TITLE: CHANGE OF ZONE NO. 3406, from R-2 Residential to O-3 Office Park PUD, and the Legacy Square Office Center Final Planned Unit Development, requested by Mark Hunzeker on behalf of Jerry and Janet Joyce, on property generally located at 81st & "O" Streets.

LINCOLN/LANCASTER COUNTY PLANNING STAFF REPORT

P.A.S.: Change of Zone #3406

PROPOSAL: Change of zone from R-2 to O-3 including a Final Plan for a Planned Unit Development.

DRAWING SHOWING PROPOSED NEW AREA OF R-2 ZONING
 USED FOR PARKING, 274 SF + 668 SF = 942 SQUARE FEET (942 LESS THAN 1200)

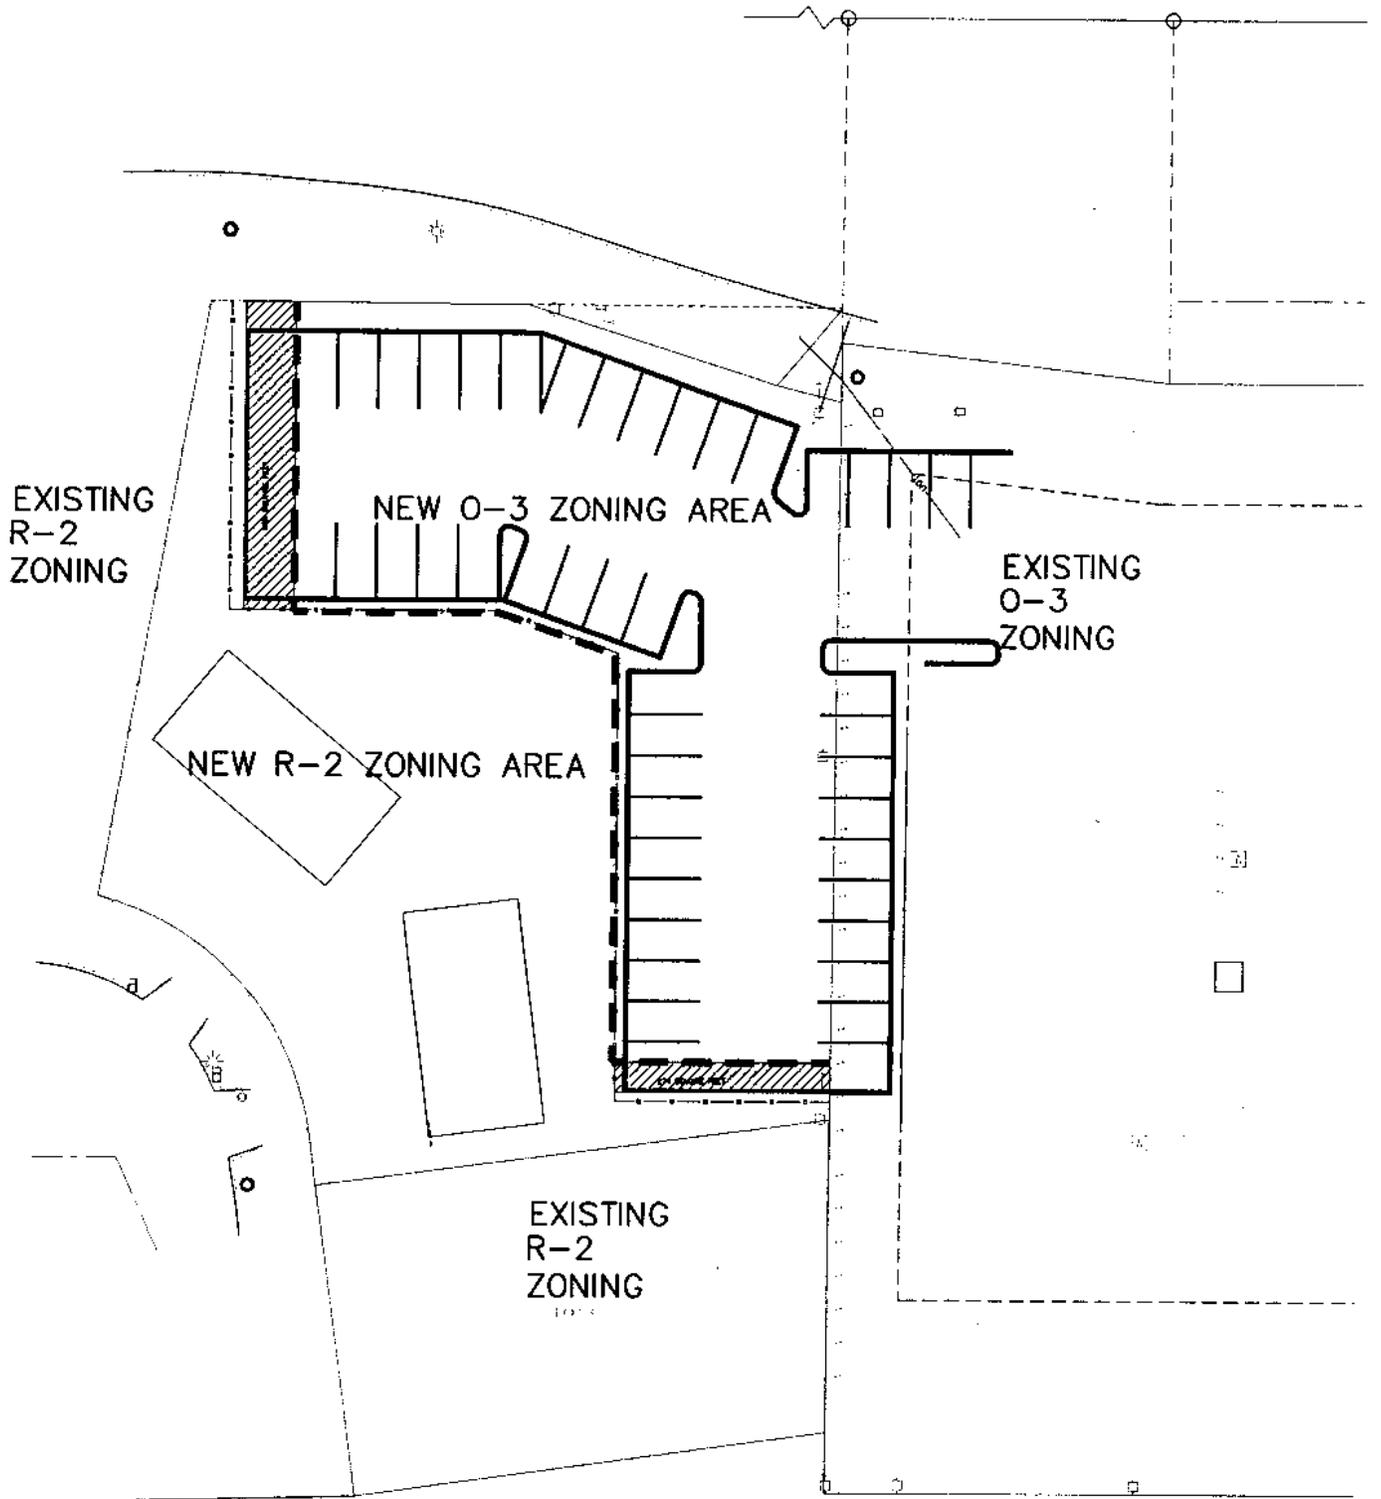
NEED A WAIVER OF MINIMUM LOT SIZE, NOT DENSITY CALCULATION

NEED A WAIVER OF REAR YARD SETBACK ON LOT 5

NEED A WAIVER OF THE FRONT YARD SETBACK
AND SCREENING REQUIREMENTS FOR 0-3 AREA

NEED TO RECALCULATE DRAINAGE REQUIREMENTS

NEED A WAIVER OF SIDE YARD SETBACK ON 0-3 AREA
